Demolition of existing structures and construction of a 16 storey mixed-use development comprising tourist accommodation, café and associated building work.

274 North Terrace, Adelaide

020/A039/19

ASSESSMENT REPORT

Figure 5 – Revised waste room configuration and circulation

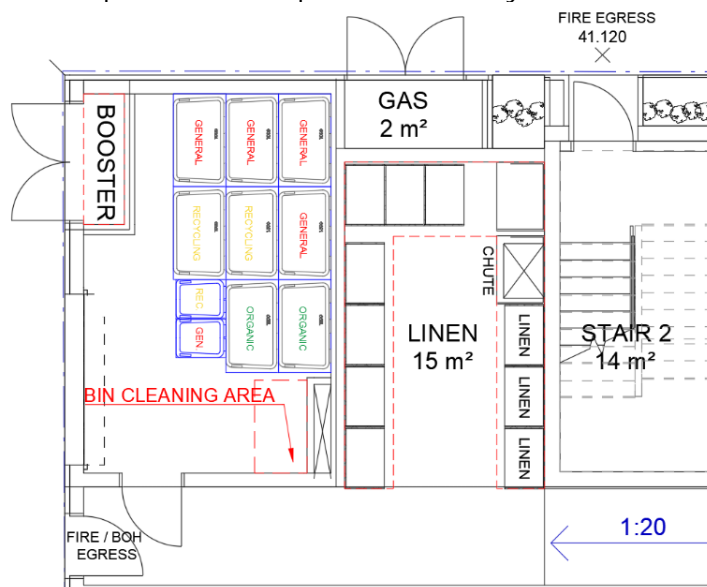
- There is insufficient circulation space provided in the waste room for serviceability/access to bins.
- DPTI should be made aware that the notional bikeway design shown in the lodgement plans is indicated only and is not representative of the working design drawings. Whilst we can give some assurance that some level of off-peak loading will be available adjacent to the proposed hotel, details of such are still in design development. Due to the developing nature of the drawings, we are not in a position to release plans at present.

- Bin wash area not clearly identified in drawing, if present it is too small to fit work in process.
- The drawings provided has not included the required 240 litres bins as per waste management strategy.

- No place for other collections (hard waste).
- 660 litre organic bins might be too heavy handling and manoeuvring, if presently completely full.
- No indented parking will be accommodated on Frome Street as per sheet 89. CoA require 1m clearance from parked cars to the bikeway to prevent injury to bike riders from being hit by car doors.

A revised waste management strategy was provided, which increased the waste collection frequency from two to three times per week and reduced the number of bins. The waste room has also been reconfigured to include a bin cleaning area and confirmation that waste collection on-street will be established on Frome Street in consultation with Council.

The applicant has since provided a revised waste management plan, which has increased the frequency of waste collections from two to three times a week and has reduced the number of bins. The waste room has been reconfigured to include a bin cleaning area and conformation has been provided that collections will occur outside of peak traffic times. The revised waste strategy removes the waste collection area from Frome Street and recognises that the bins will be collected directly from the waste storage room by a private contractor, reducing the potential impact to the footpath and bikeway.

After ODASA review

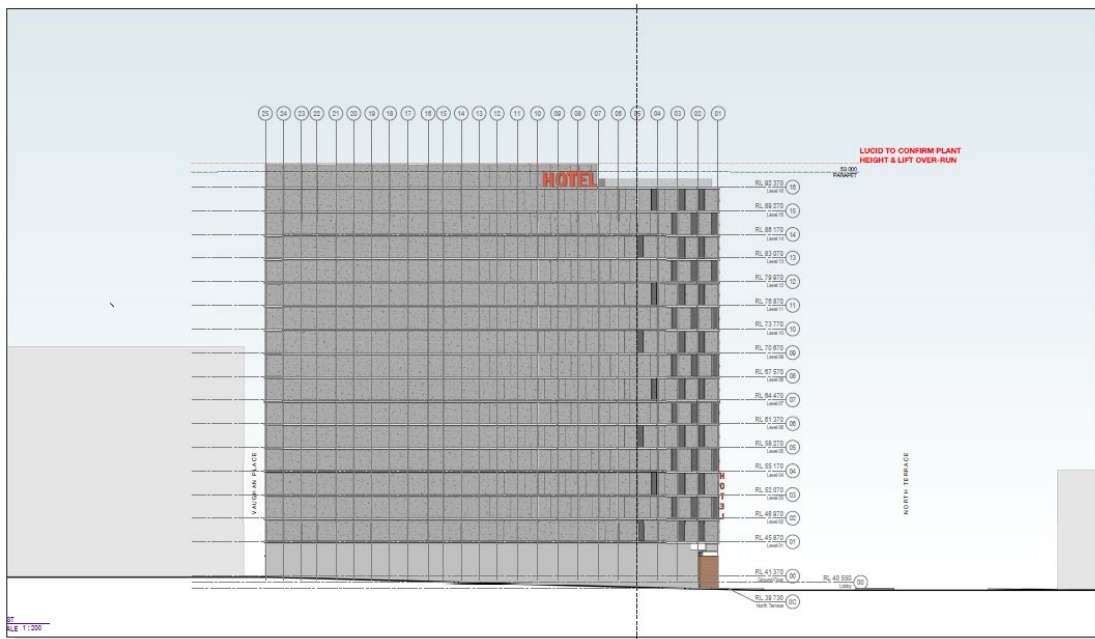
Before ODASA review
